Re: Comments of Iberdrola Renewables, Inc. regarding the Tule Wind Project Draft DEIR/DEIS- Modified Project Layout

Tule Wind, LLC, a wholly owned subsidiary of Iberdrola Renewables, Inc. (IRI), submits this letter to summarize proposed minor modifications to the Tule Wind Project since the project was submitted to you with IRI's Applicant Environmental Document (AED) in September of 2010. Submitted herewith is a modified project layout in GIS format and other information, such as recently completed surveys and technical studies that have been revised based upon the Tule Wind Modified Project Layout. Enclosed with this letter are specific suggested edits to the Draft Environmental Impact Report/Environmental Impact Statement (EIR/EIS) in "track changes" format to help facilitate incorporation of the minor changes resulting from the Modified Project Layout into the Final EIR/EIS as the applicant's proposed project. IRI submits this information to the Lead Agencies to supplement IRI's comments on the Draft EIR/EIS for the Tule Wind Project submitted under separate cover.

Figure A-3: Preliminary Underground Alignment Drawing 5 of 10

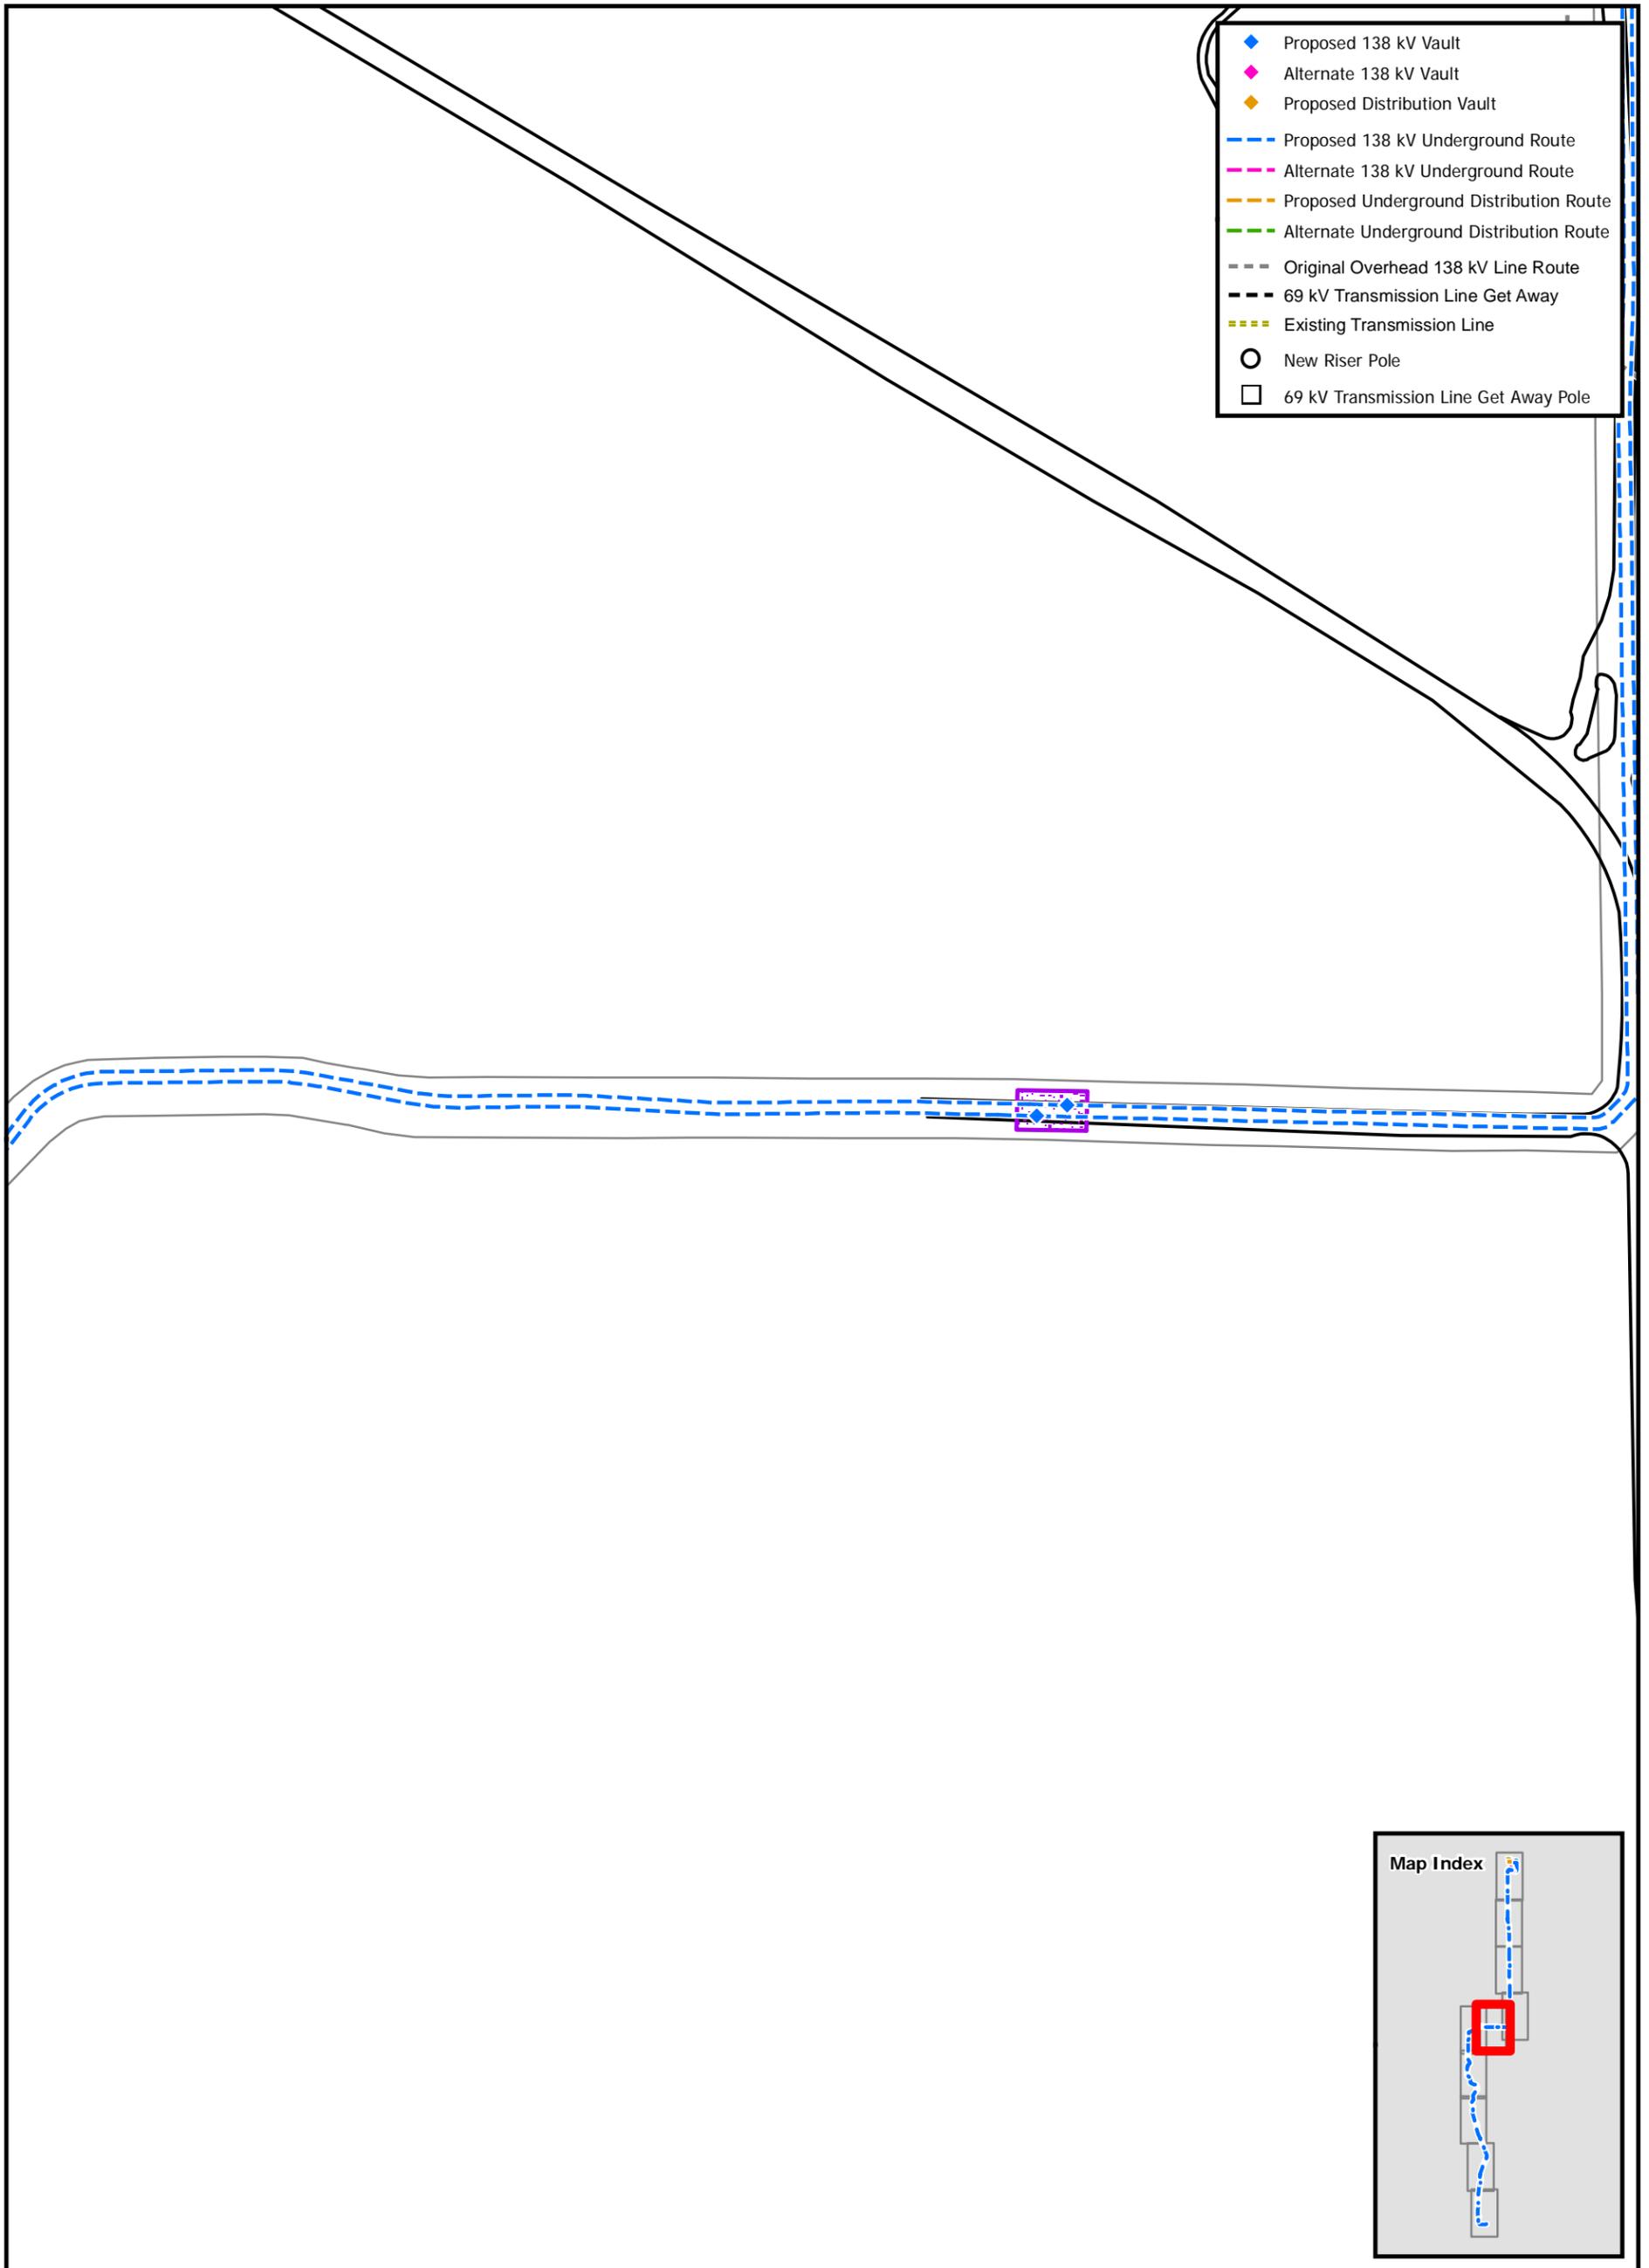
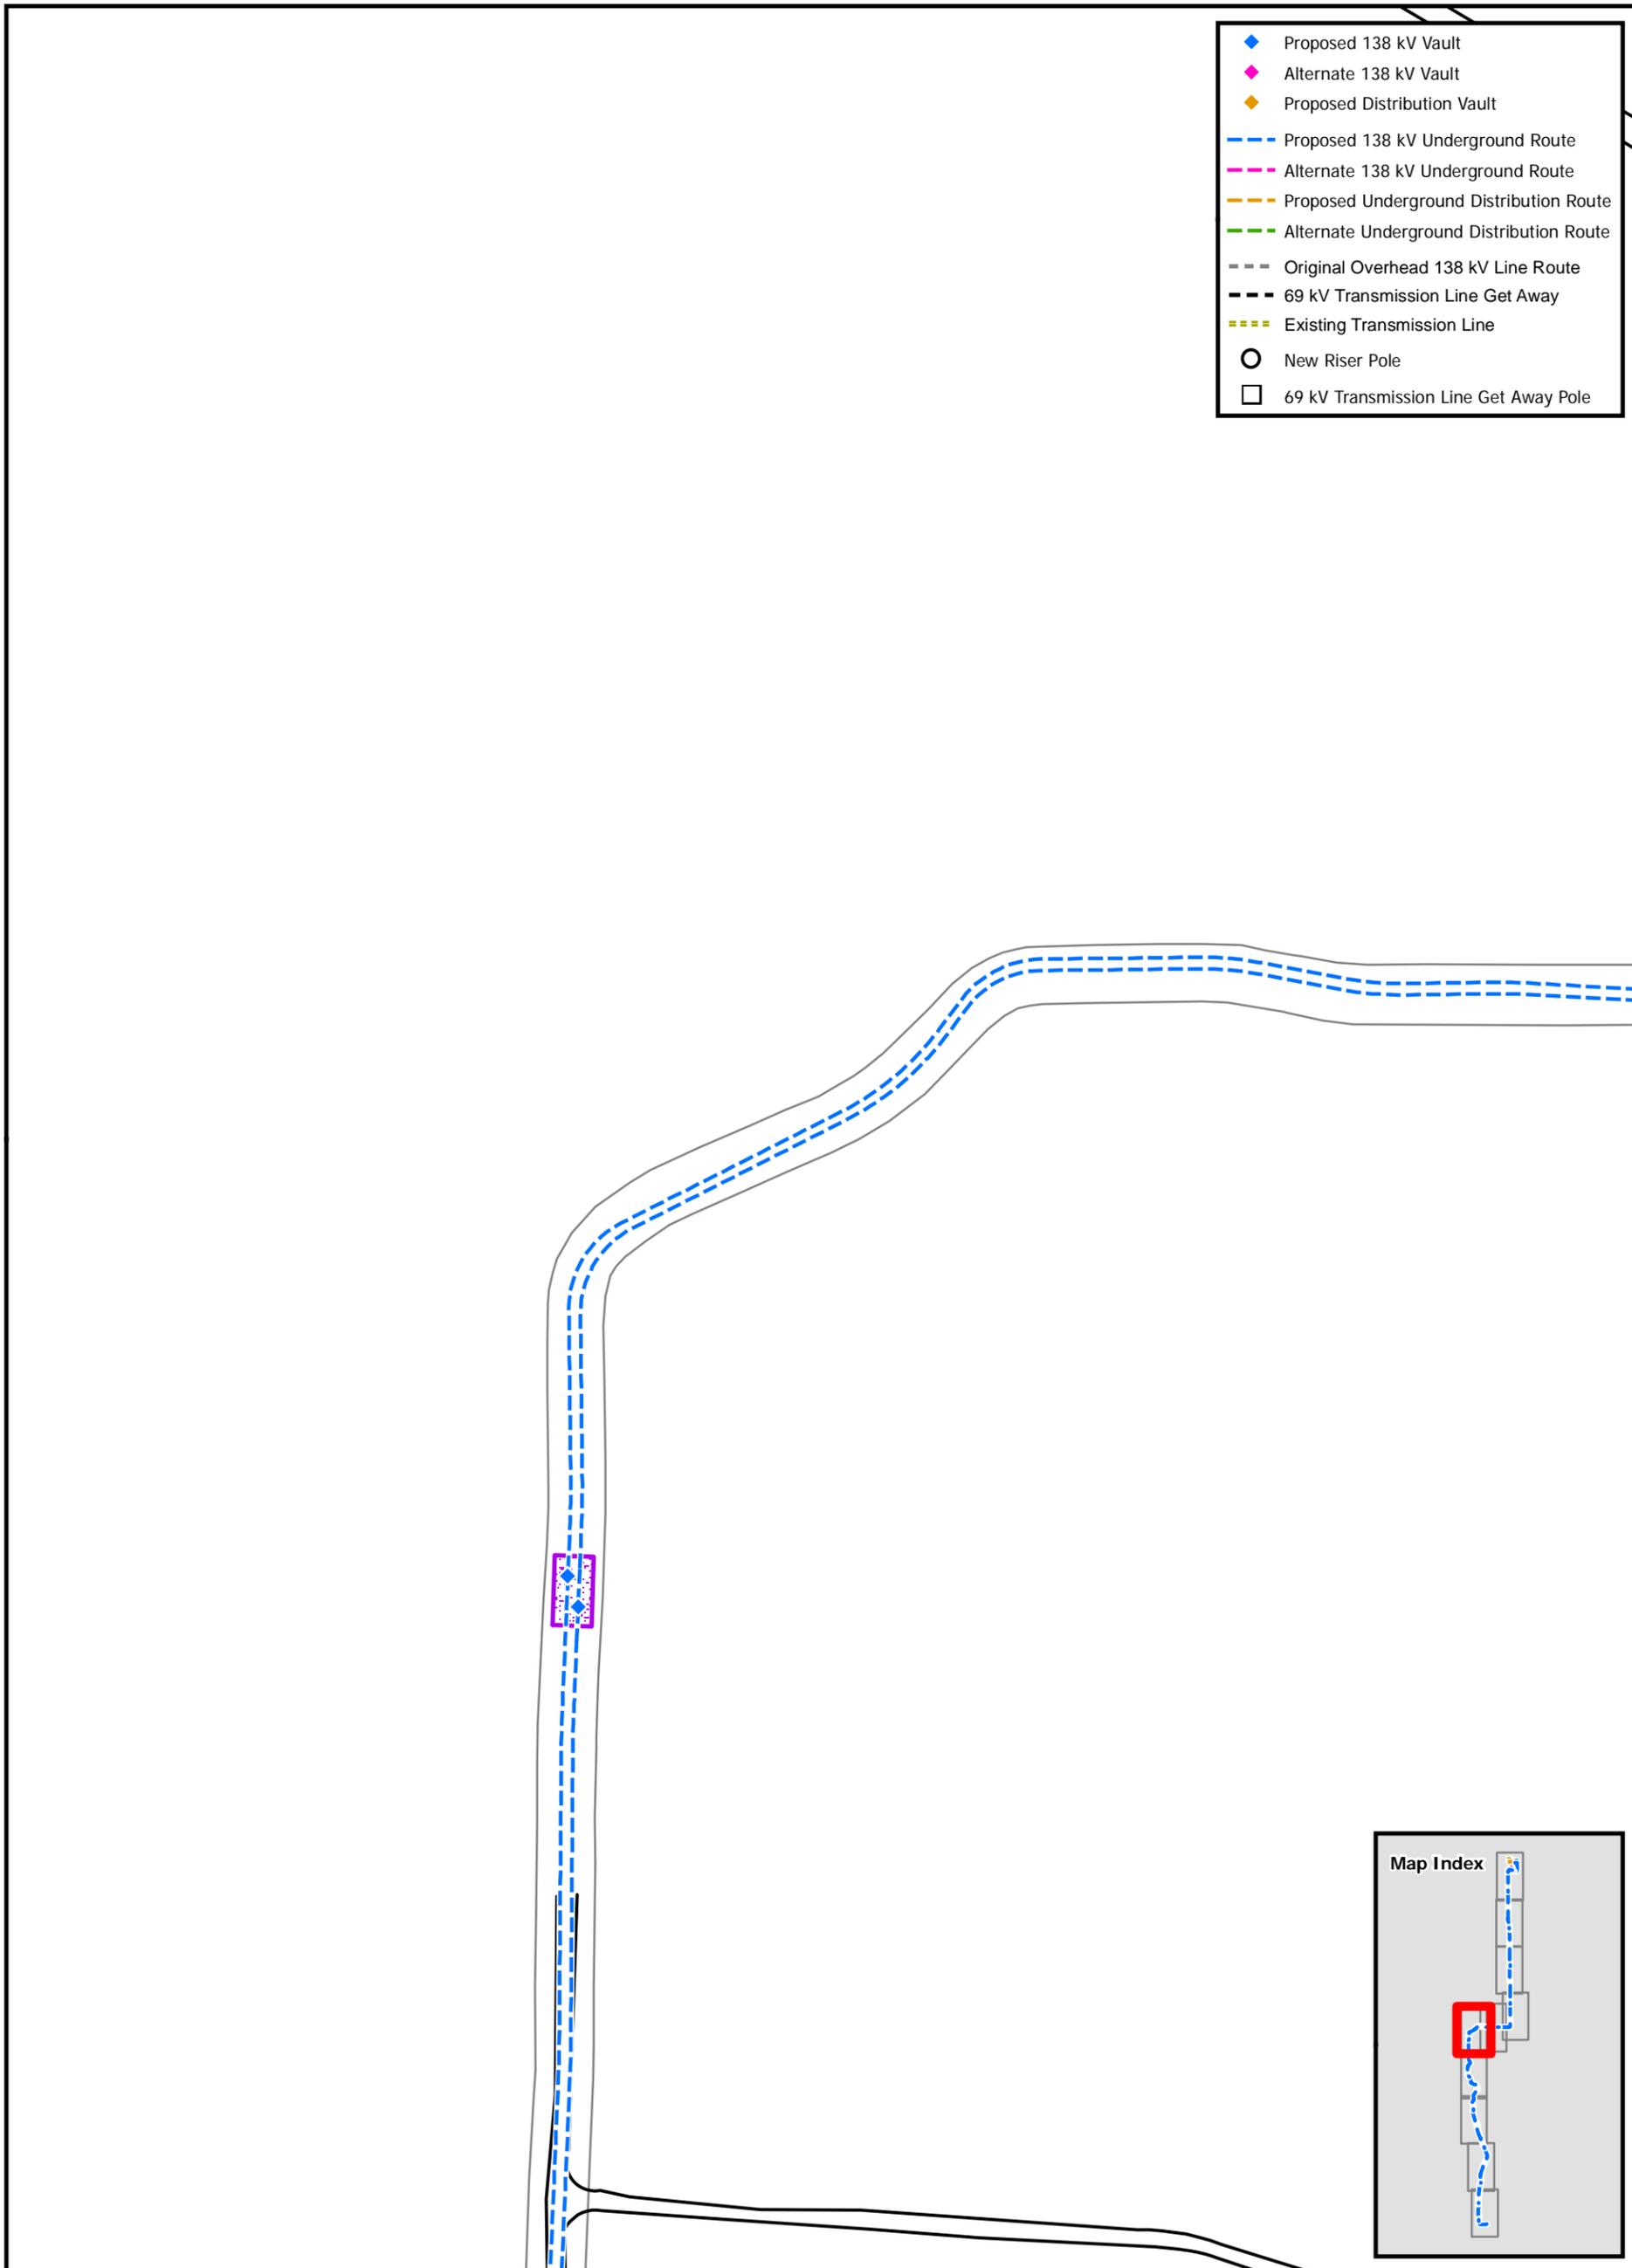
In order to assess the potential impacts to biological, cultural, and hydrological resources from the partial underground portion of the Project, field surveys of the area were conducted in February 2011. From the results of these surveys, SDG&E prepared a feasible preliminary design of the underground section of the Partial Underground Alternative, which is depicted in the attached Figure A-3: Preliminary Underground Alignment Drawing. Based on this preliminary design, the overhead portion of the 138 kV transmission line would transition to an underground configuration at two new riser poles located within the same permanent pole work area previously designed for steel pole 38. From these two new riser poles, two parallel duct banks separated by up to 20 feet would be installed typically within or directly adjacent to existing roads in the area. The duct banks would measure approximately 4.1 miles long and each would pass through approximately 11 vaults before terminating at the Boulevard Substation. The duct banks would be installed using the direct trenching method of construction in all but two locations. An approximately 690-foot-long segment would be installed using the horizontal directional drilling method to cross under a large jurisdictional feature and an approximately 280-foot-long segment would be installed using the jack-and-bore method to cross under an existing San Diego & Arizona Eastern railroad.

The impacts of the underground alignment were then determined based on a worst-case scenario (since there are two alternative routes into the substation as depicted in Figure A-3: Preliminary Underground Alignment Drawing that are substantially similar). As demonstrated in Table A-7: Preliminary Partial Underground Impacts, these impacts would not be substantial and would not therefore be significant.
